NOTICE OF MEETING

PLANNING COMMISSION
DATE: 7/28/14
AGENDA ITEM: 4A – PUBLIC HEARING
CASE # 2014-30

ITEM: Boulder Ponds – Preliminary Plat and Preliminary PUD Plan

Pebblestone Ridge Cove - 12" Watermain Loop

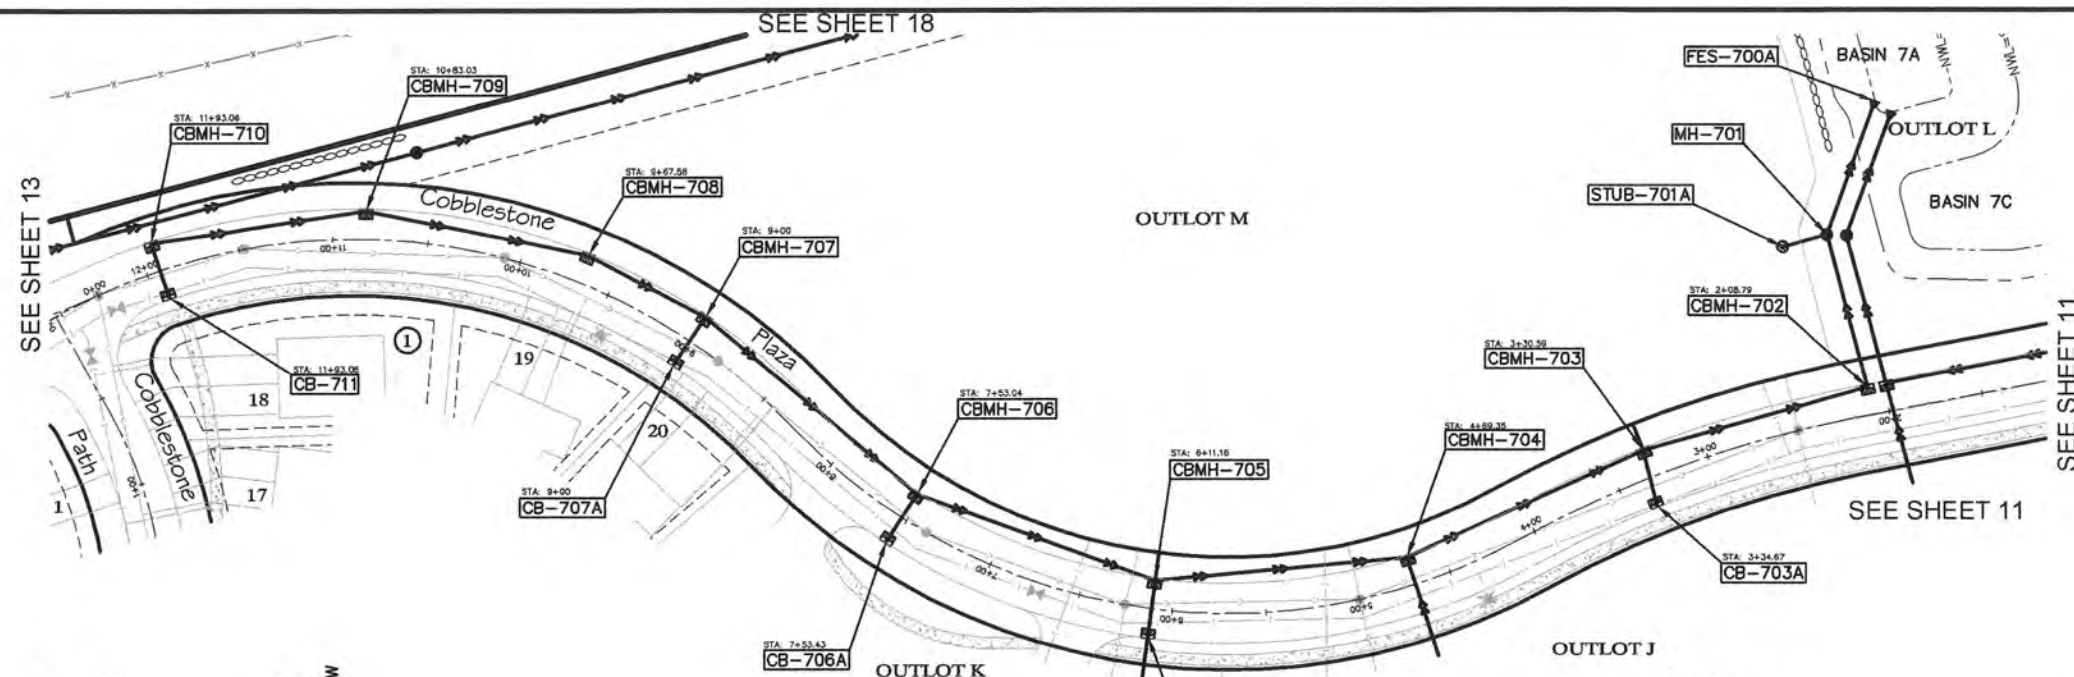
- Profile elevation labels must be corrected for accuracy.
 - The existing watermain must be shown in plan and profile along Hudson Boulevard.
 - Correct "Existing Ground" and "Proposed Grade" call-outs on Sheet 9, Pebblestone Ridge Cove – 12" Watermain Loop Profile.

Cobblestone Path &
Pebblestone Ridge Cove

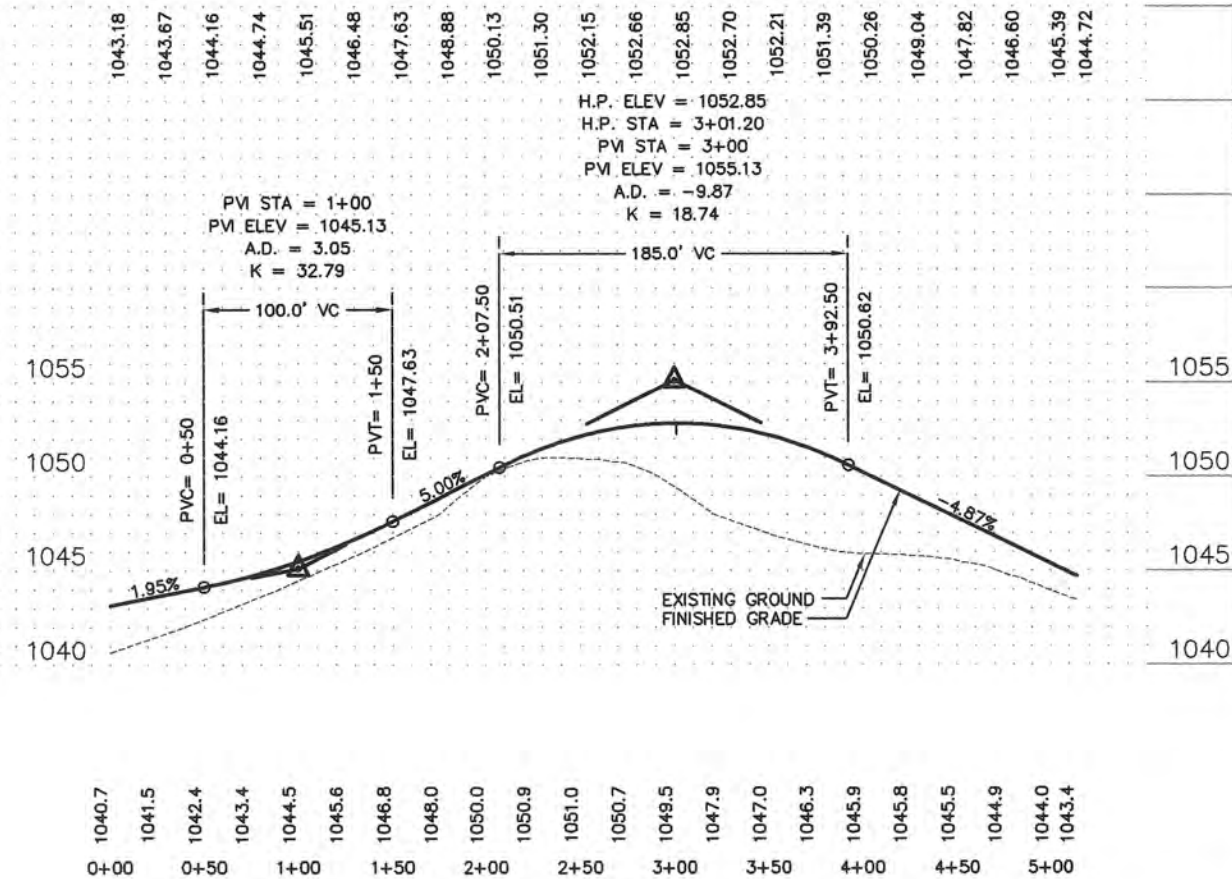
- The Pebblestone Ridge Cove Plan View on sheet 24 must be revised to plan scale to facilitate plan review.
- Cul-de-sac geometry must be revised as follows:

HUDSON BOULEVARD

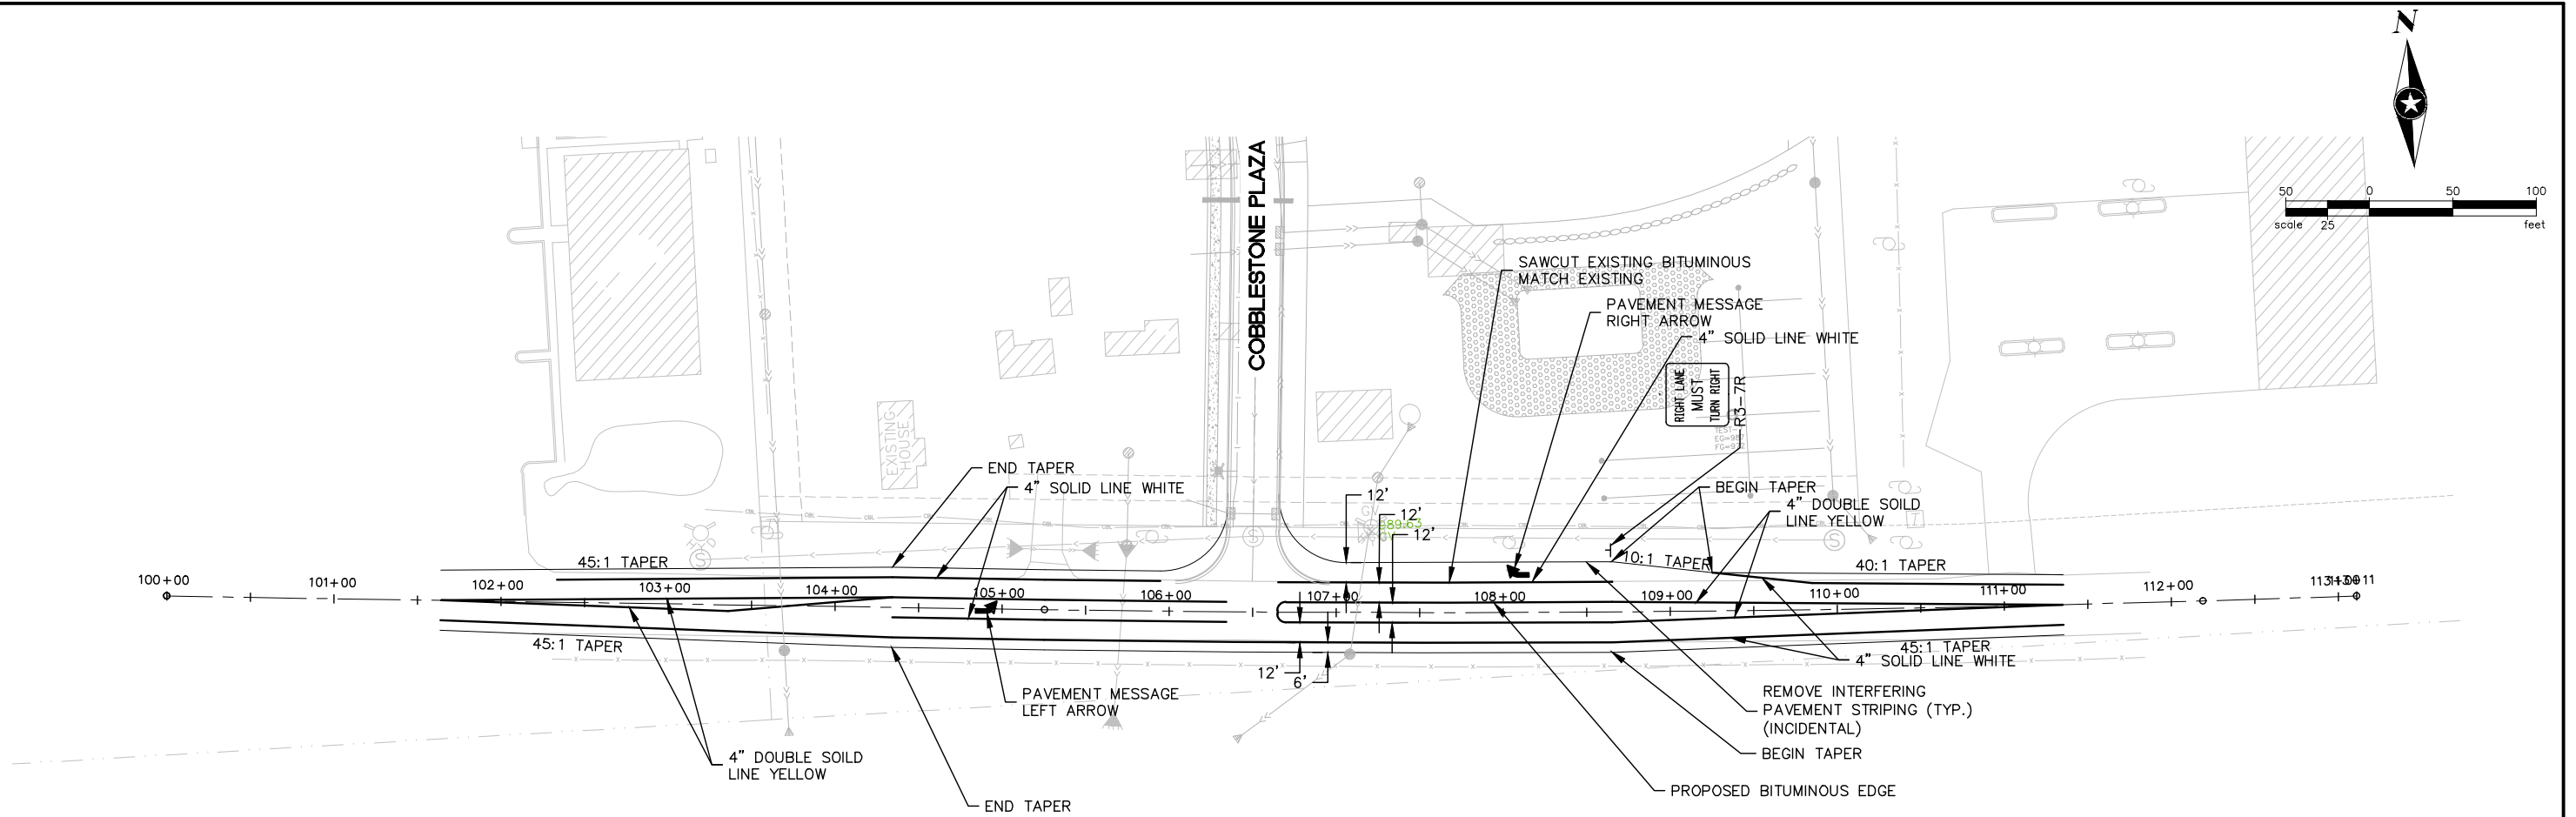
- Dedicated turn lanes are being provided along Hudson Boulevard to access the development at Cobblestone Plaza. The signing and striping plan for Hudson Blvd, Sheet TL1, must be updated to meet the current posted 50 mph design speed.
